ADDENDUM No. Two (2)

**Construction, Collin County Walking Trail, Pedestrian Bridge Placement
IFB No. 2013-094**

Effective: May 7, 2013

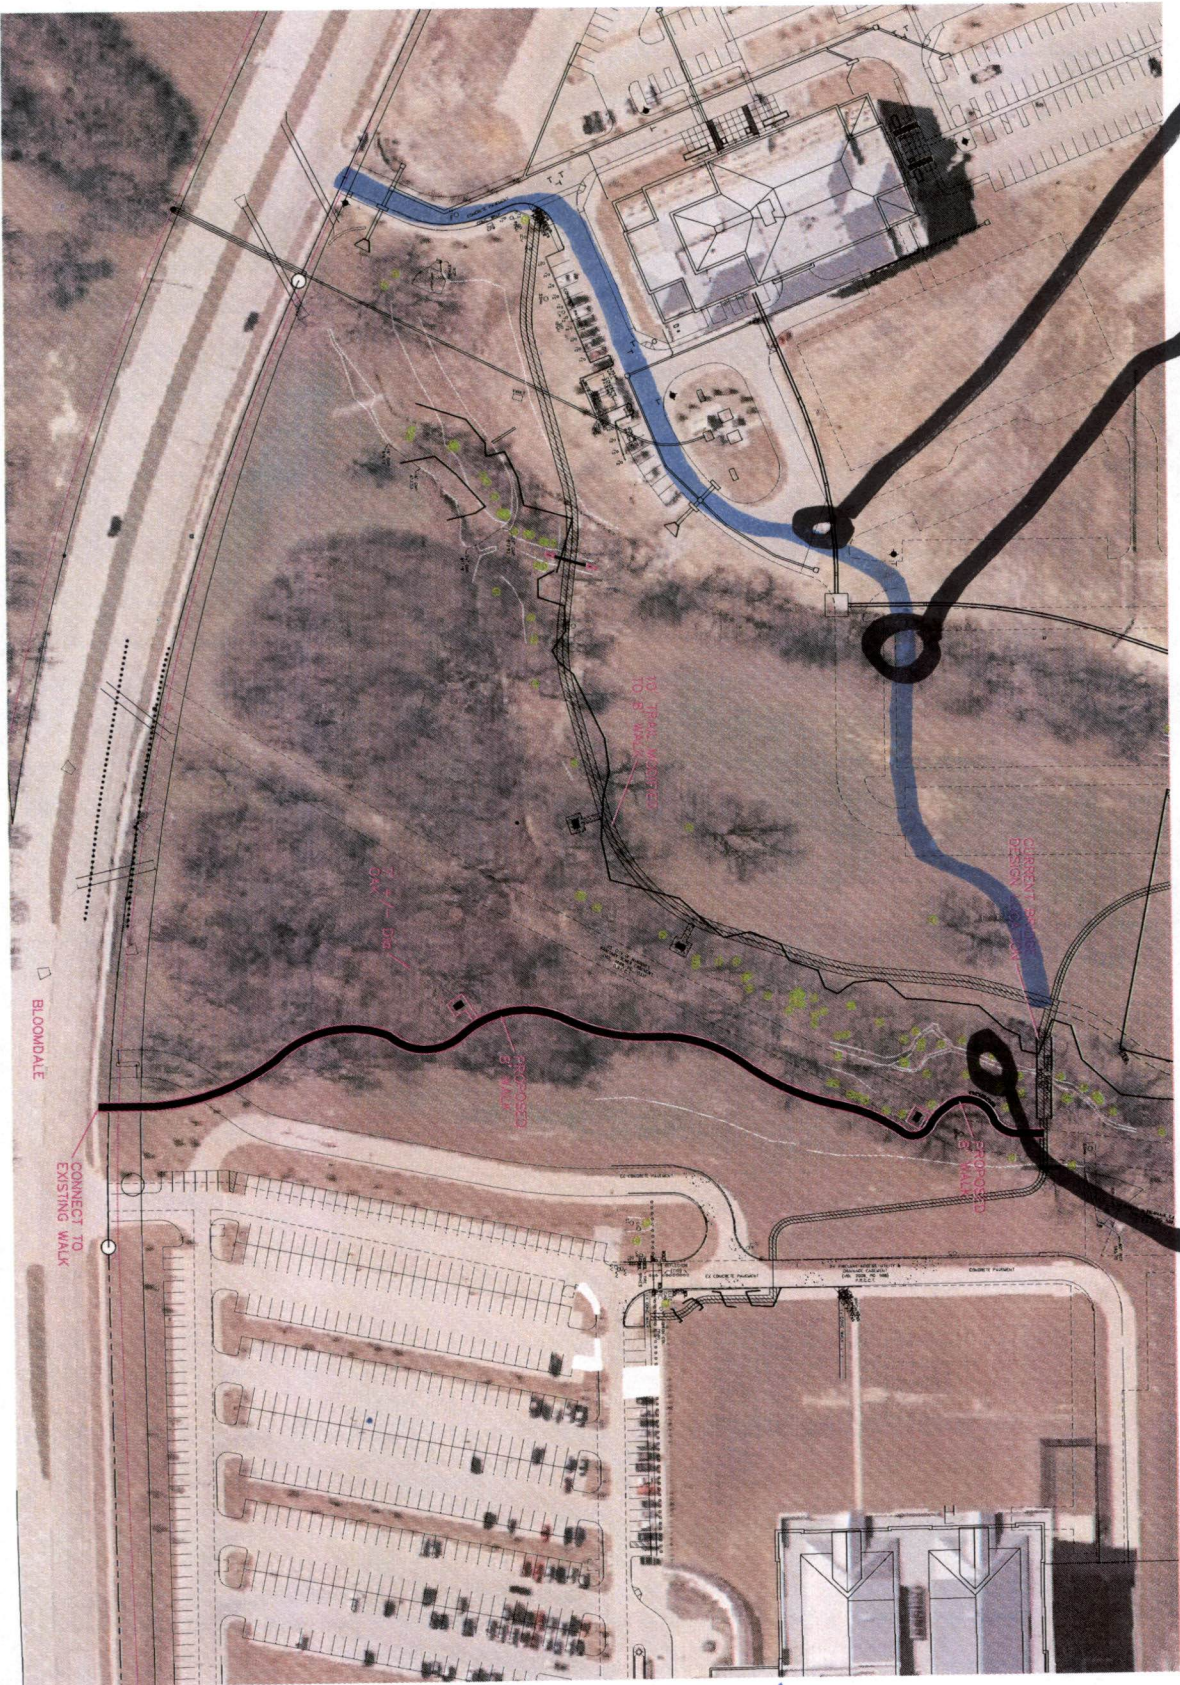
Protect curb

Remove crossing - fill with rock and trim trees as needed. Remove rock when complete.

Check crossing - fill with rock and trim trees as needed. Remove rock when complete.

Distance from curb to bridge approximately 600 ft.
